INCH CAPE ONSHORE SCOPING REPORT - REQUEST FOR A SCOPING OPINION UNDER REGULATION 17(1) OF THE TOWN AND COUNTRY PLANNING (ENVIRONMENTAL IMPACT ASSESSMENT) (SCOTLAND) REGULATIONS 2017

INCH CAPE ONSHORE

Inch Cape Onshore Transmission Works

Scoping Opinion under Regulation 17(1) of the Town and Country Planning (Environmental Impact Assessment) (Scotland) Regulations 2017

Fig 1: Substation Indicative Layout

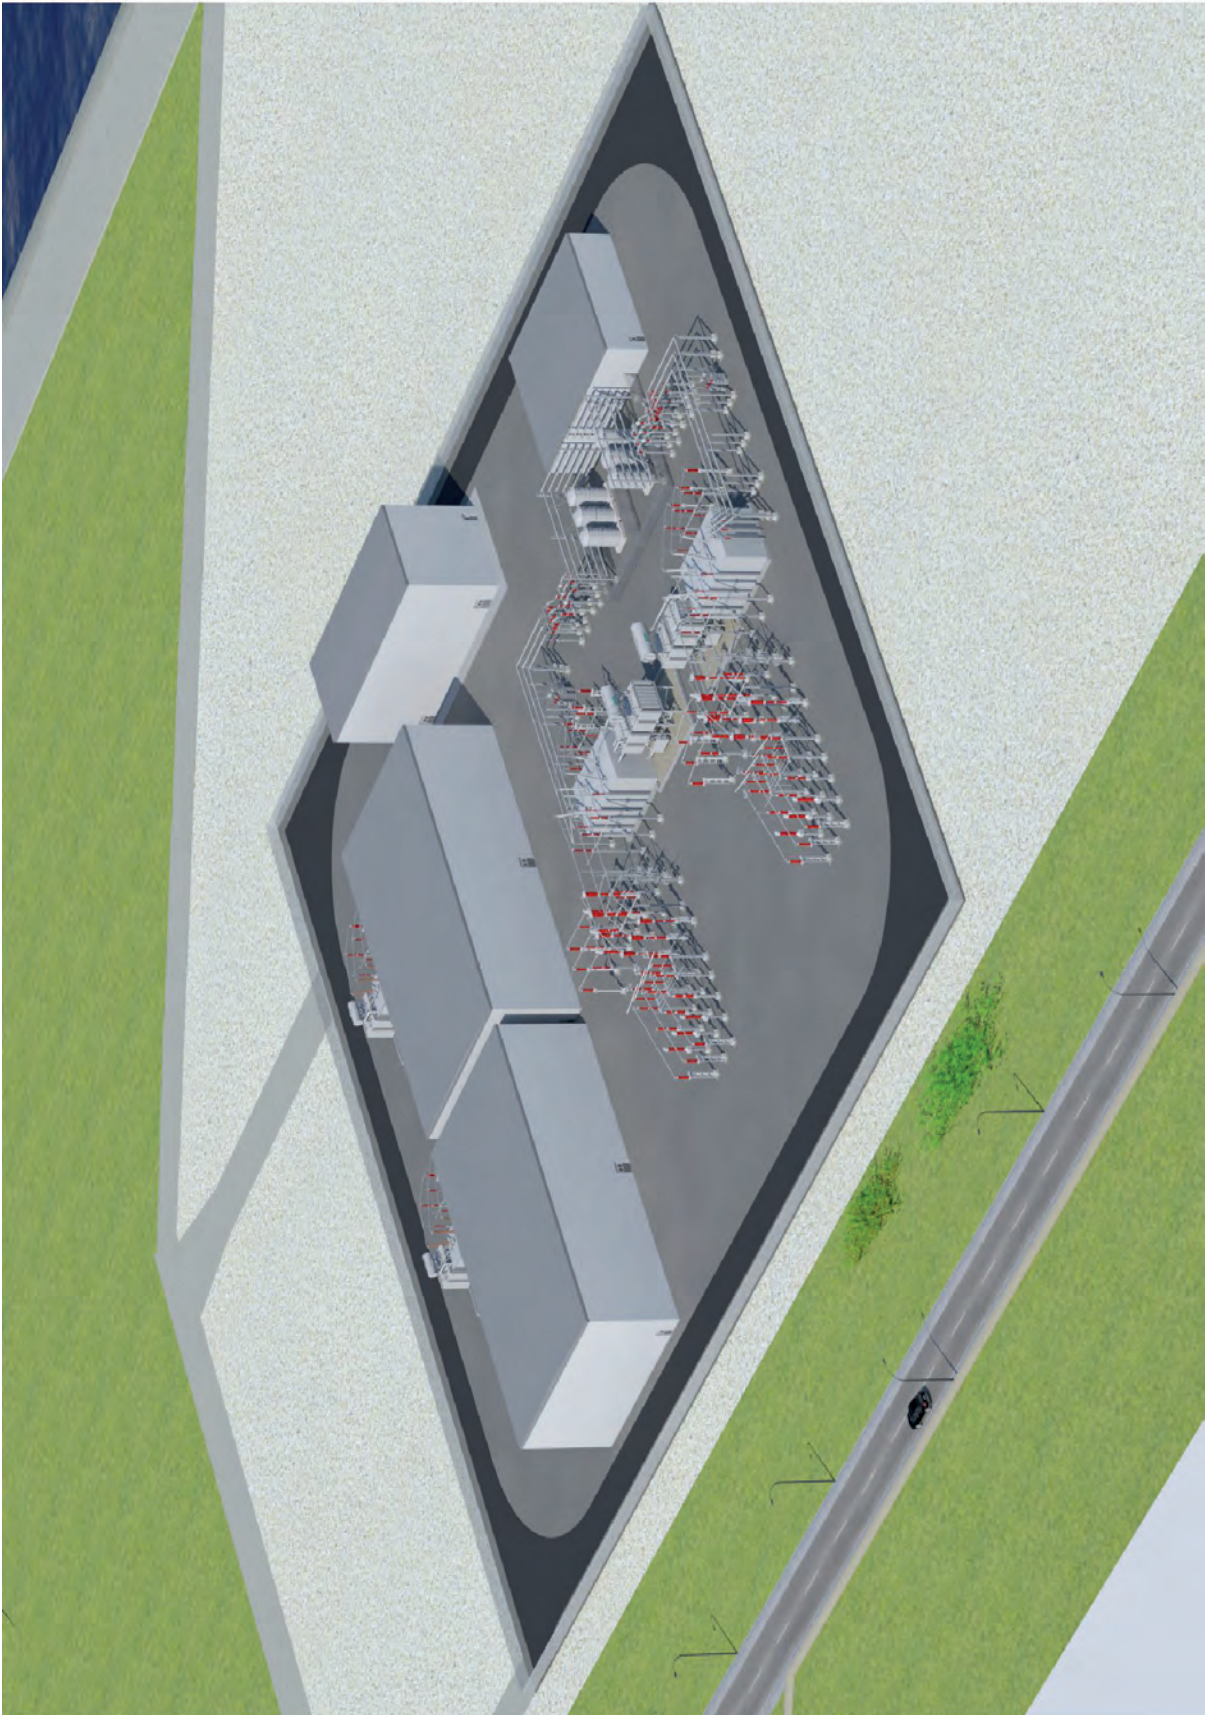
1. The indicative layout referred to in Paragraph 48 of the Scoping Report which does not appear to be included within the Scoping Report:
2. ZTV diagram and proposed viewpoints be submitted as a shapefile.

The indicative layout for the substation (with a note to the effect that further design work is being carried out) and shapefiles were supplied. The Indicative Layout is shown below, along with a map based on the shapefiles supplied. The map is presented for information purposes over and was prepared by ELC in good faith based on information supplied by ICOL. It is similar to Figure 8.1 in the Scoping Report, though showing a larger base map area.
